***MODIFICATION REQUEST:  
Stages 2 and 3, Site 3 Mixed Use  
Development  
Australia Avenue, Sydney Olympic Park  
(MP 10\_0027 MOD 4)***

***Minor design changes and conversion of  
rooftop plant area into additional residential  
floor space***

Secretary's Environmental Assessment Report  
Section 75W of the  
*Environmental Planning and Assessment Act 1979*

October 2014

Figure 3: Tower 1 Proposed Level 24

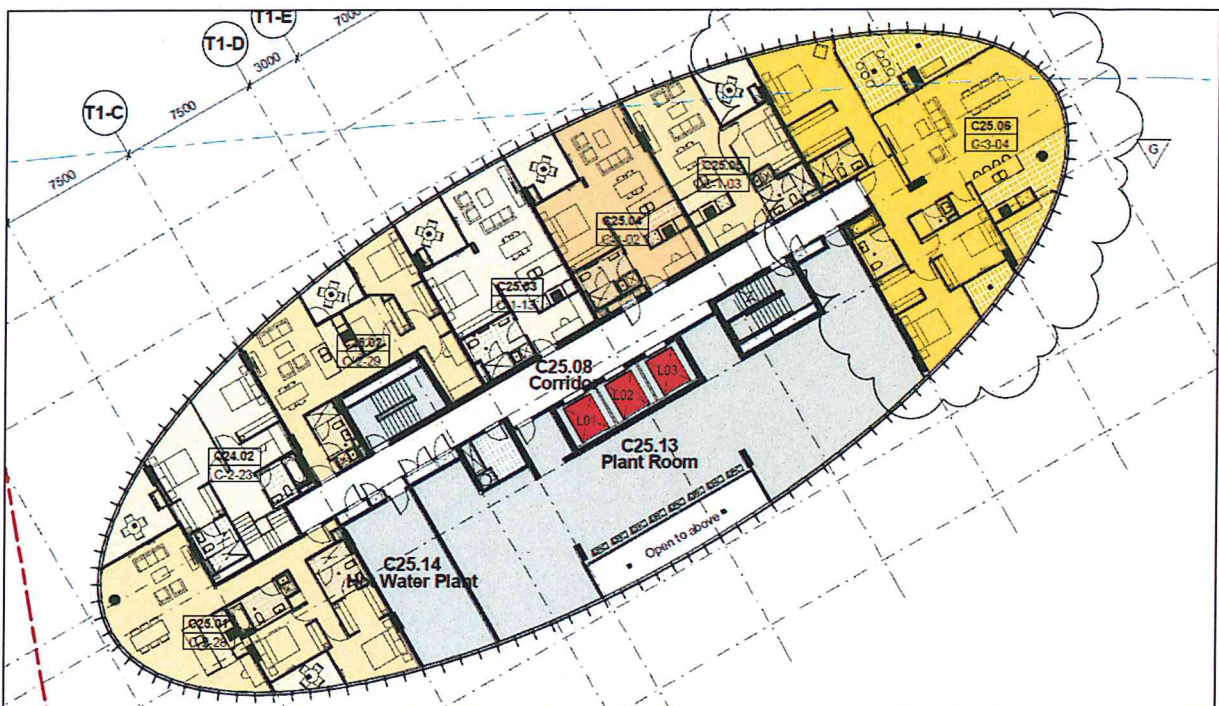
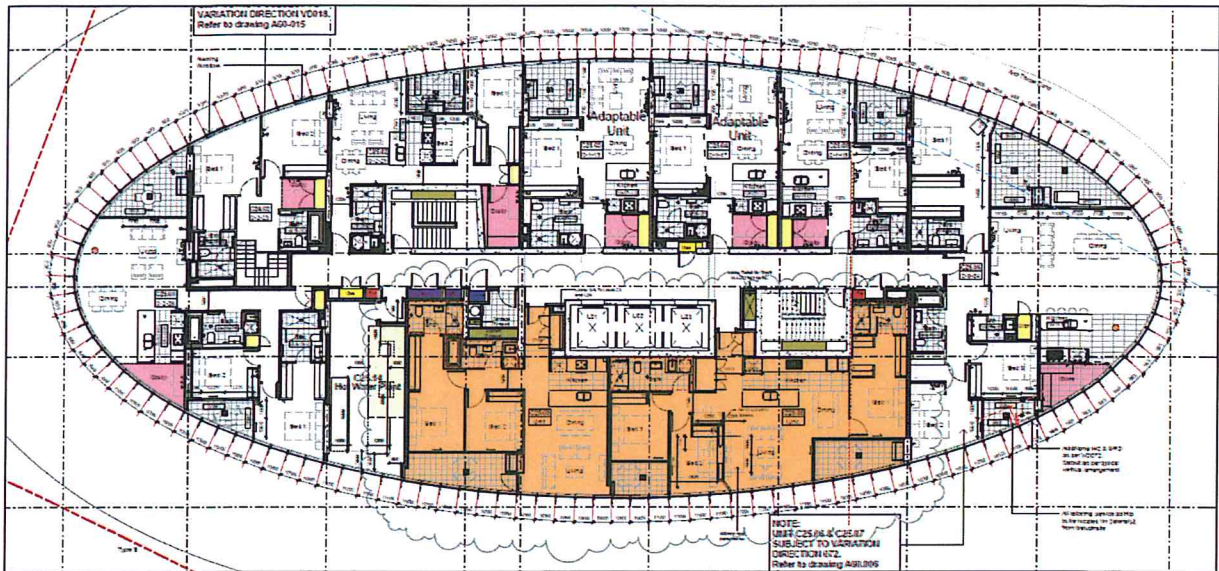
The rooftop plant areas for Tower 1 and 2 have been reduced in size through detailed design work and the proponent is seeking approval to convert this surplus plant area into additional residential floorspace (see **Figures 2 to 5**). The proposed additional residential floorspace (three units) is confined to the approved envelope for the rooftop plant area. The additional residential units would therefore be screened by the glazed façade curtain wall, which extends 1.05 metres above the uppermost level, resulting in no built form impacts.

**Figure 5: Tower 2 Proposed Level 30**

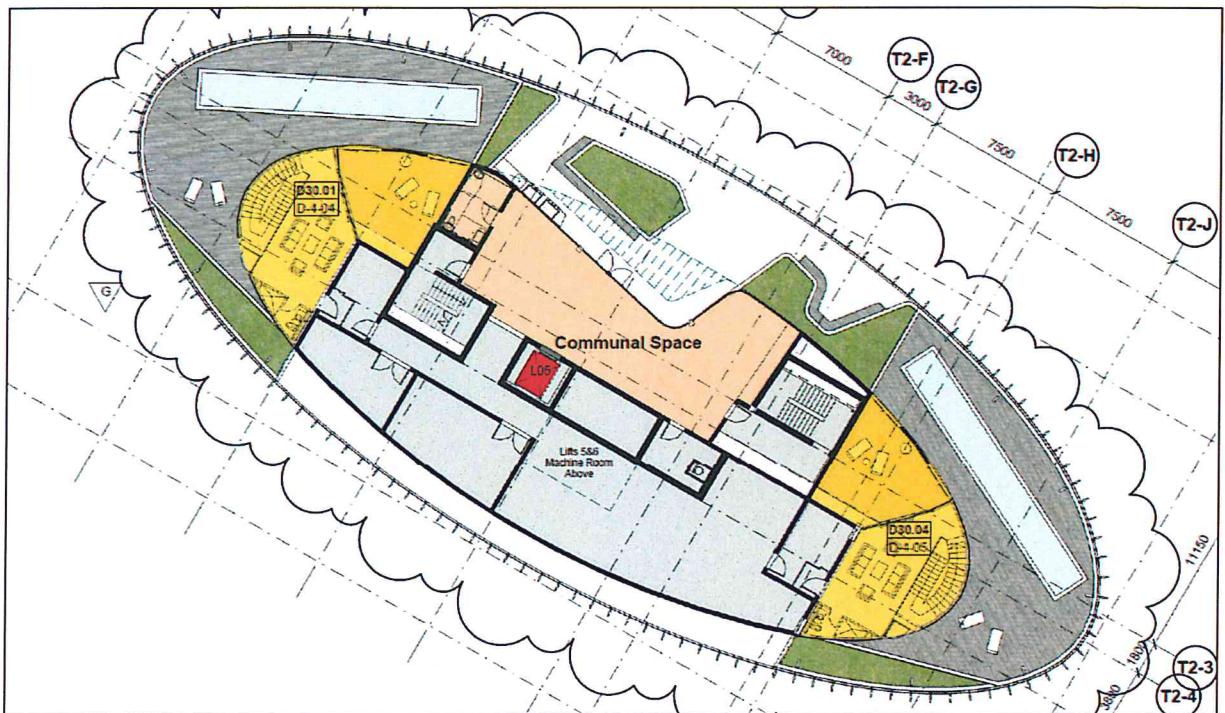
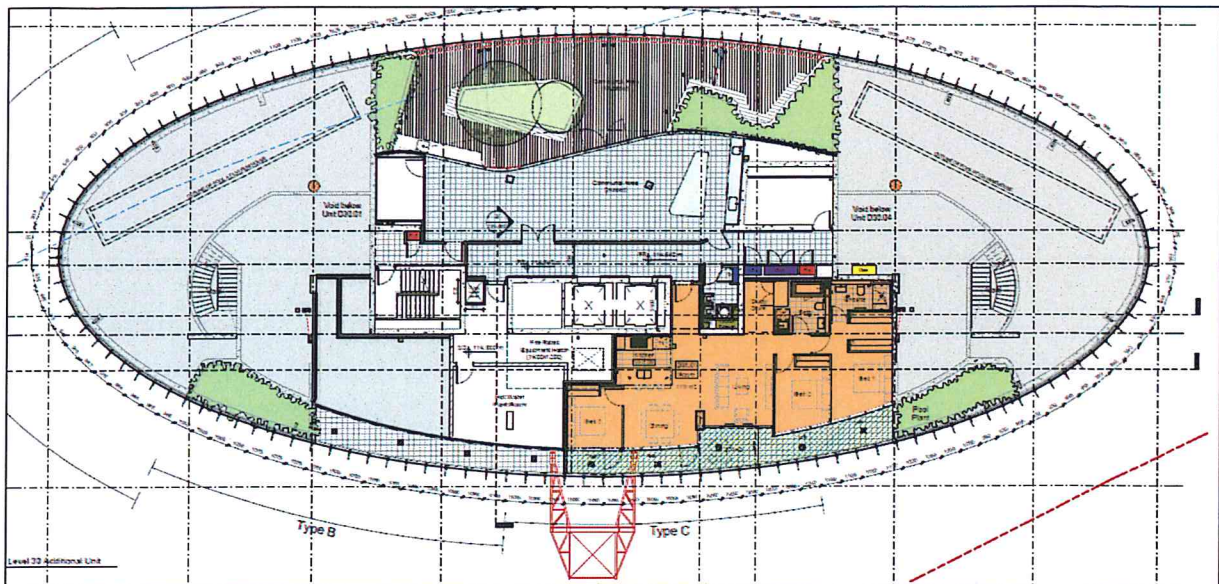
The proposed increase to the size of the internal common area on Level 30 of Tower 2 will increase the amount of floorspace but as it is located behind the glazed façade, it would also have no built form impacts.

Figure 7: Proposed Ground Floor Layout

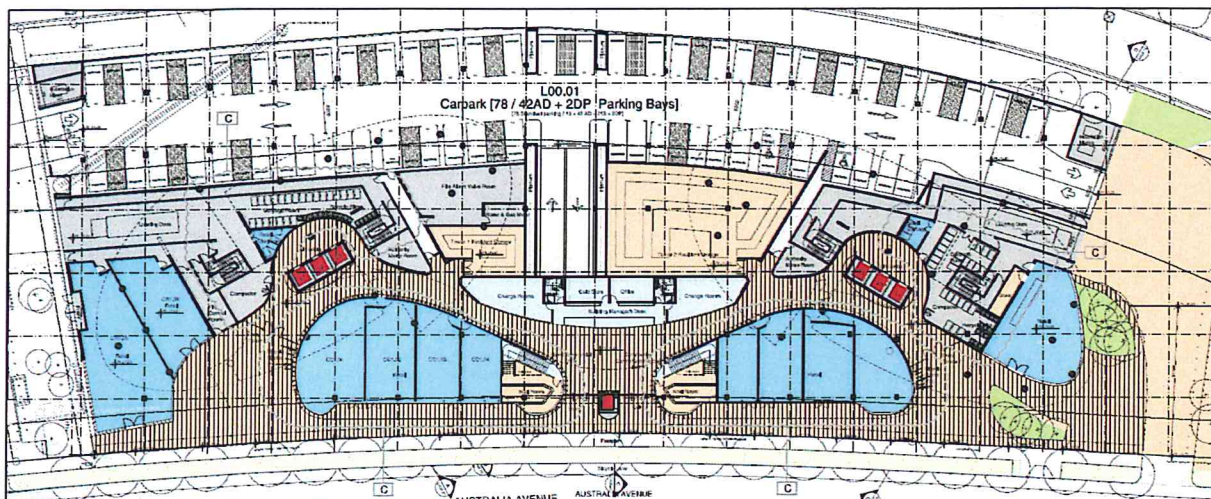
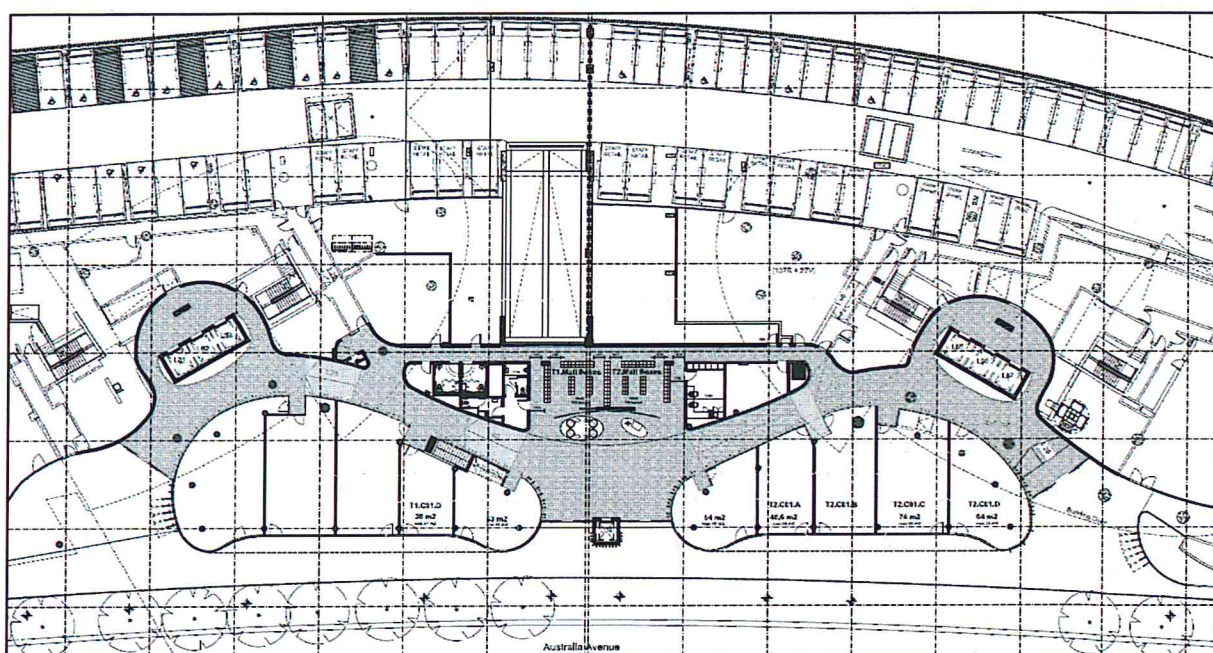
The proposed variations to the ground floor and podium levels (see **Figures 6 to 9**) are sought to provide more efficient use of the space by consolidating building management and mail rooms and removing walkways to commercial tenancies where alternate access from the tower cores can be provided. This has resulted in a marginal increase in commercial floor space (85.6 sqm), including reconfiguration of existing commercial tenancies and additional commercial tenancies where the mail rooms were previously located. The variations would result in a minor increase in gross floor area, however, as the reconfigured ground floor and podium layouts are internal and setback from the Australia Avenue frontage, they would not have any built form impacts.
